The Commission has issued the enclosed Amendment No. 14 to Provisional Operating License No. DPR-22 for the Monticello Nuclear Generating Plant. This amendment includes Change No. 22 to the Technical Specifications and is in response to your requests dated March 12, 1975 (except for items 3 and 4 thereof), and August 4, 1975, and other filings by you dated August 20, 1974, July 9, 1975, July 10, 1975 (except for that portion dealing with APRM flux scram trip setting and rod block equations), July 24, 1975 and September 16, 1975.

MONTICELLO NUCLEAR GENERATING STATION

Amendment No. 14
License No. DPR-22

CHANGE NO. 22 TO THE TECHNICAL SPECIFICATIONS

Figure 3.11.1-A
Maximum Average Planar Linear Heat Generation Rate Versus Planar Average Exposure
Monticello 7D225 Fuel

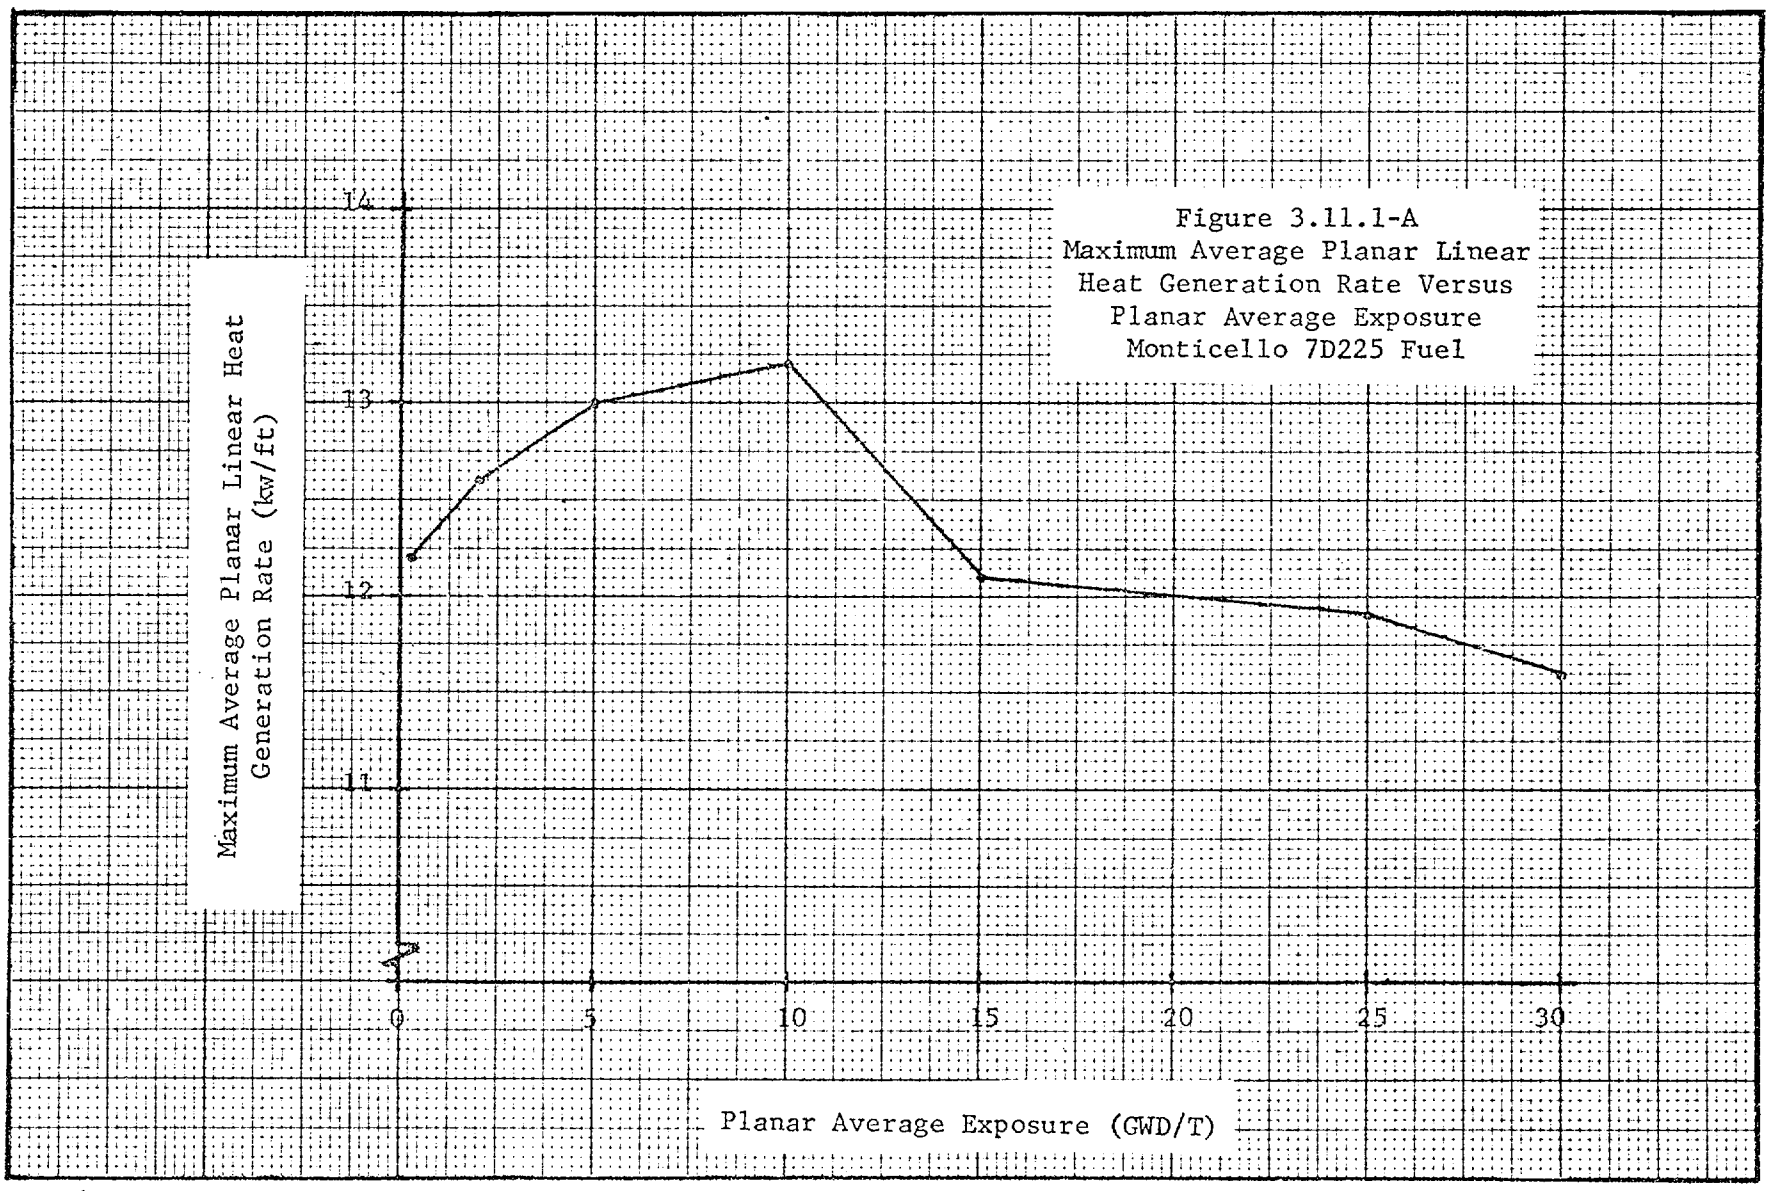
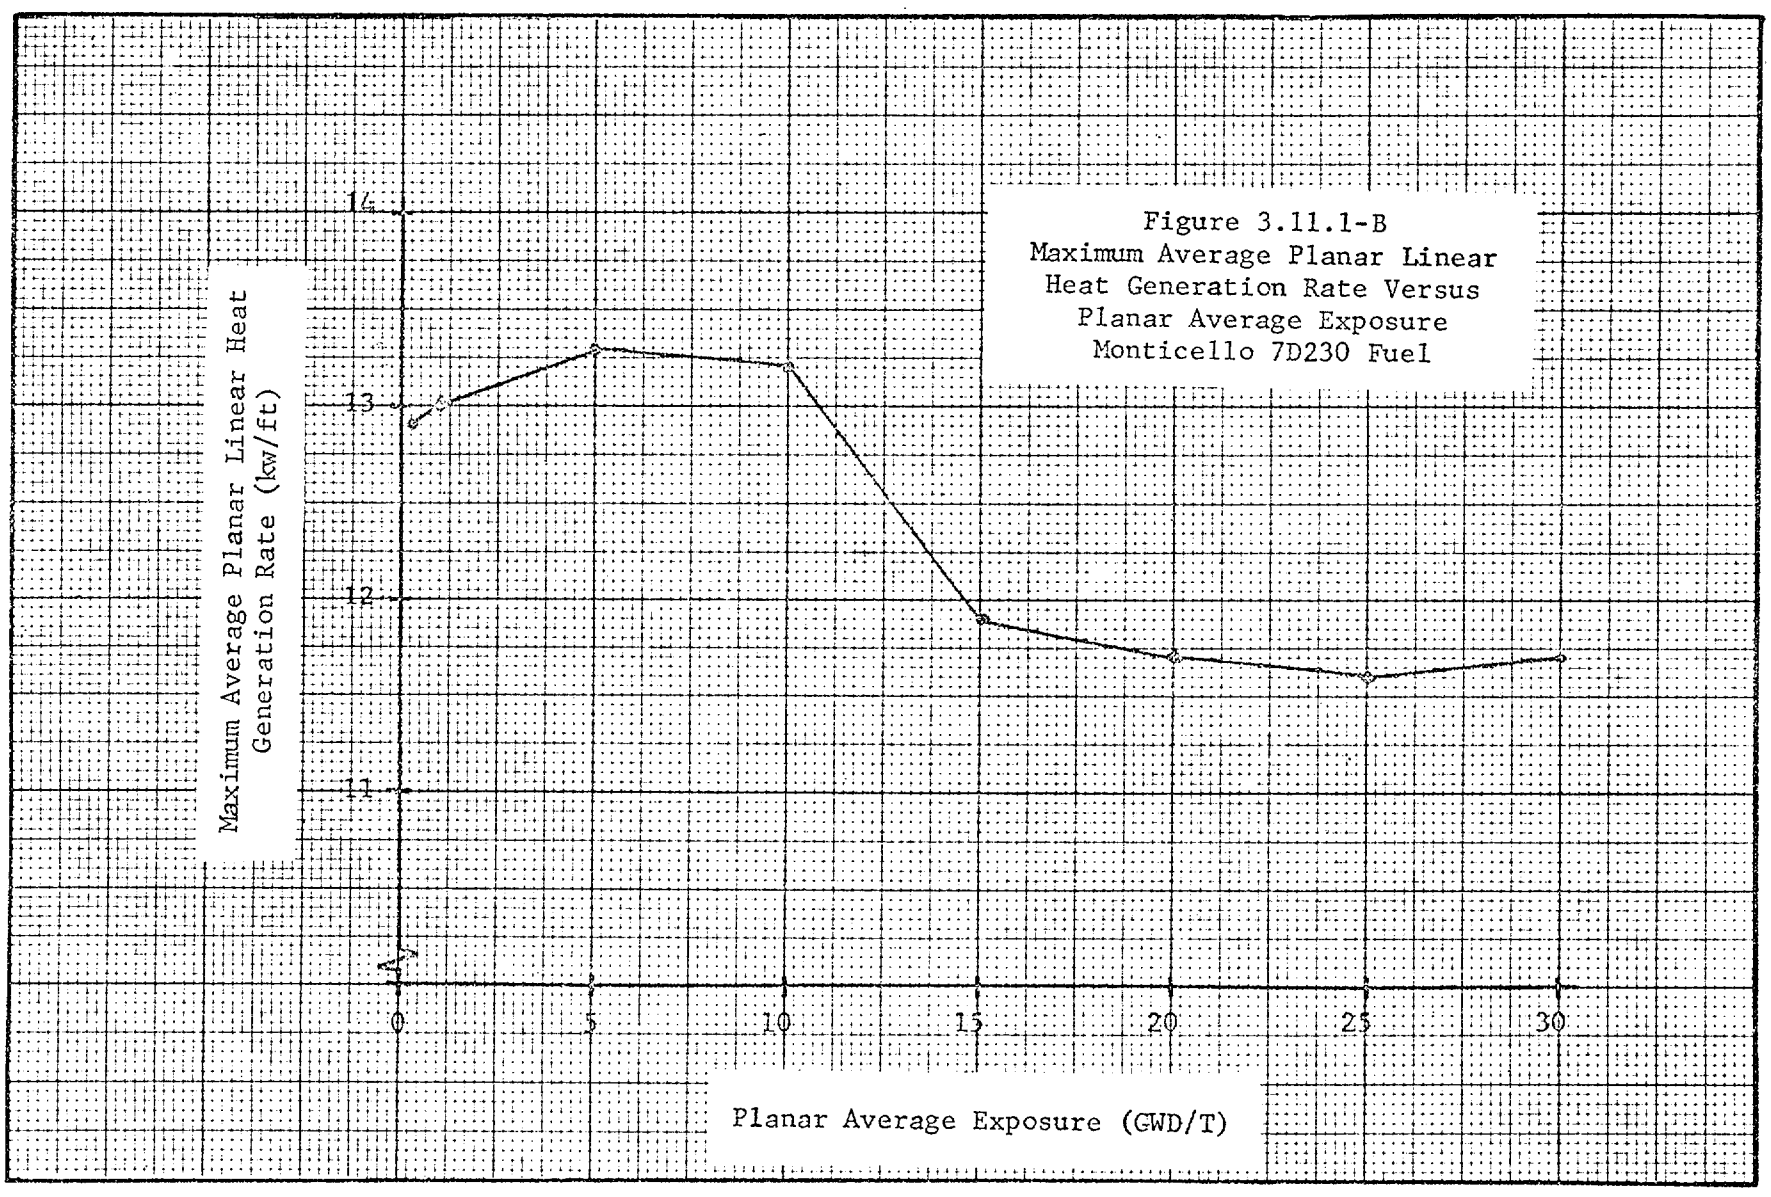
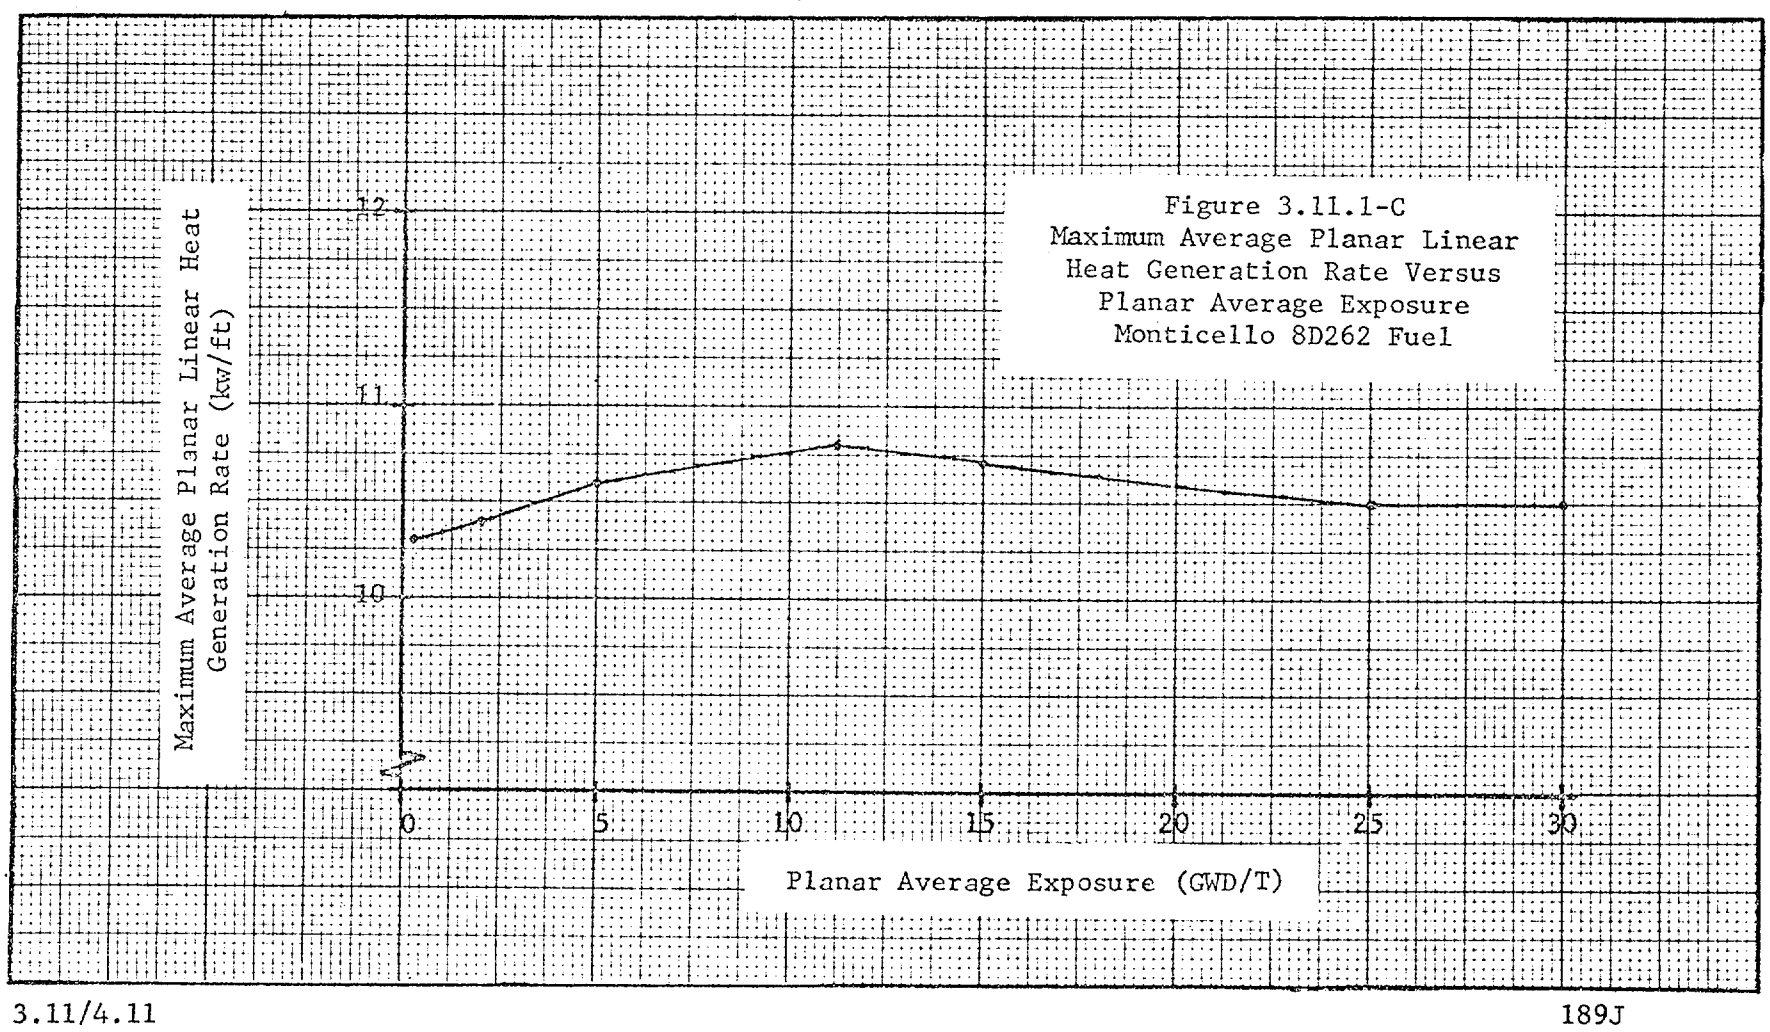
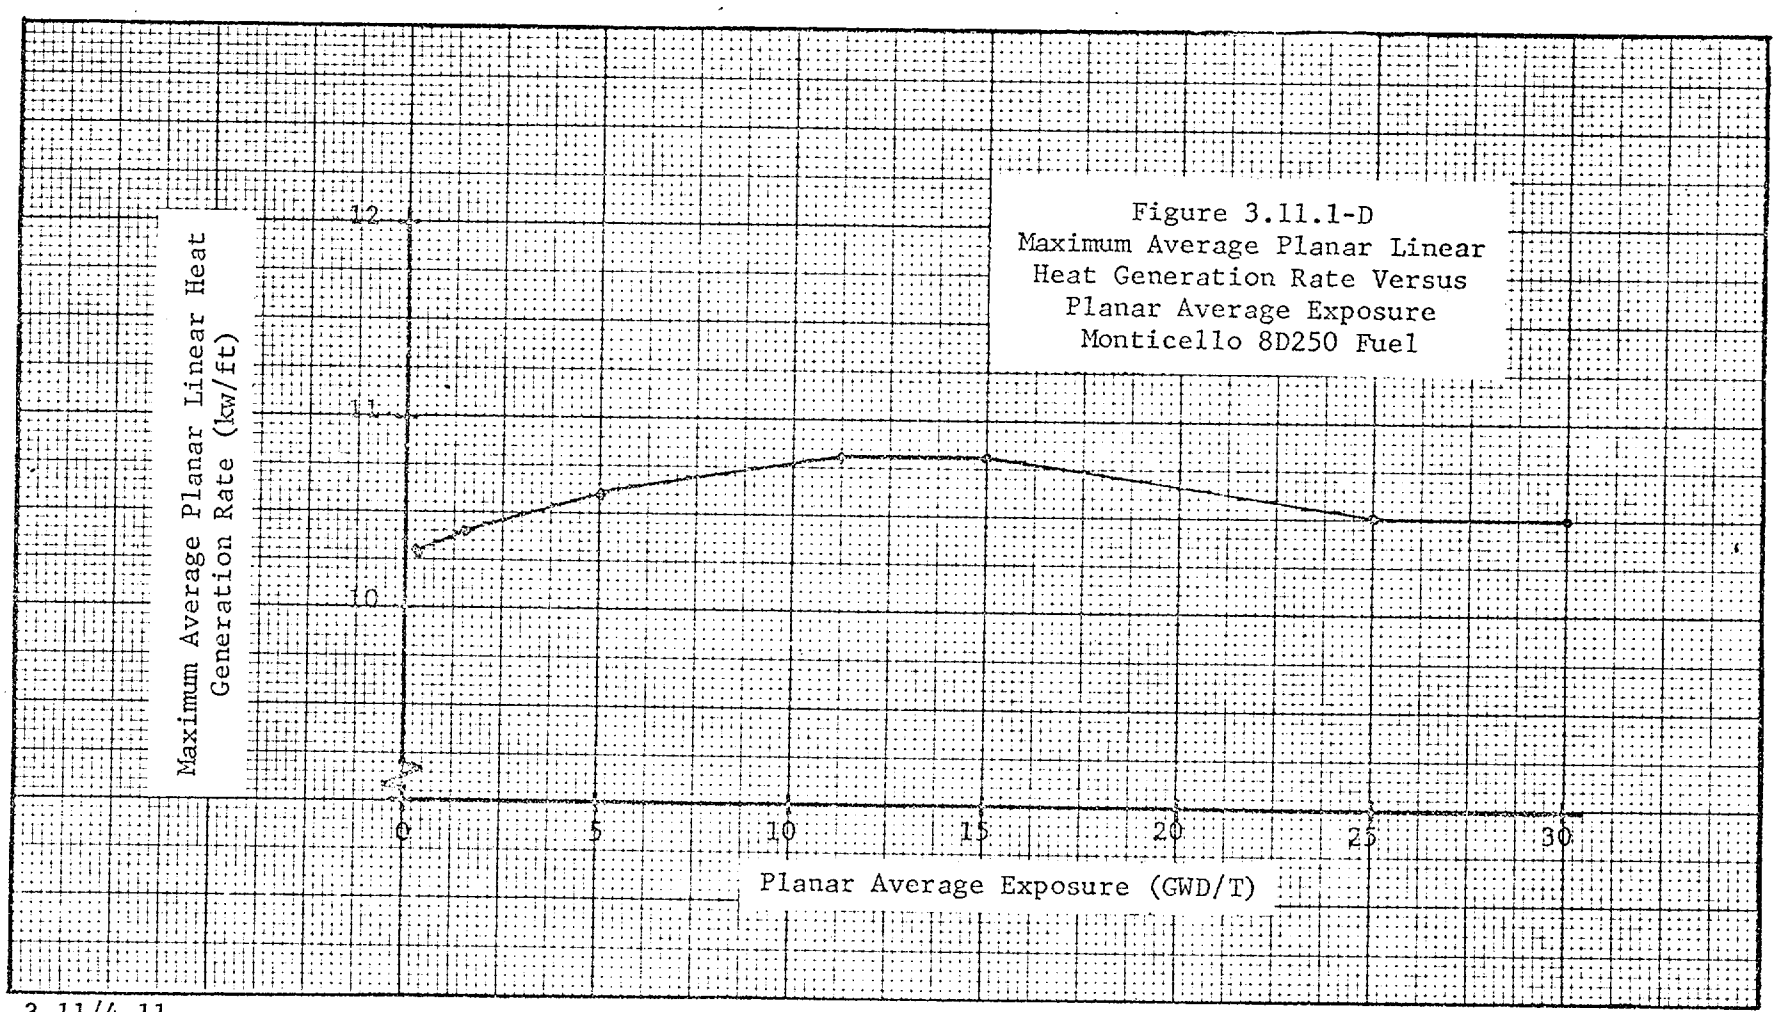
During steady state power operation, the APLHGR for each type of fuel as a function of average planar exposure shall not exceed the limiting value shown in Figures 3.11-1. If at any time it is determined that the limiting value for APLHGR is being exceeded, action shall be taken immediately to restore operation to within the prescribed limits. This occurrence shall be reported to the Office of Nuclear Reactor Regulation within 30 days of the date of occurrence.
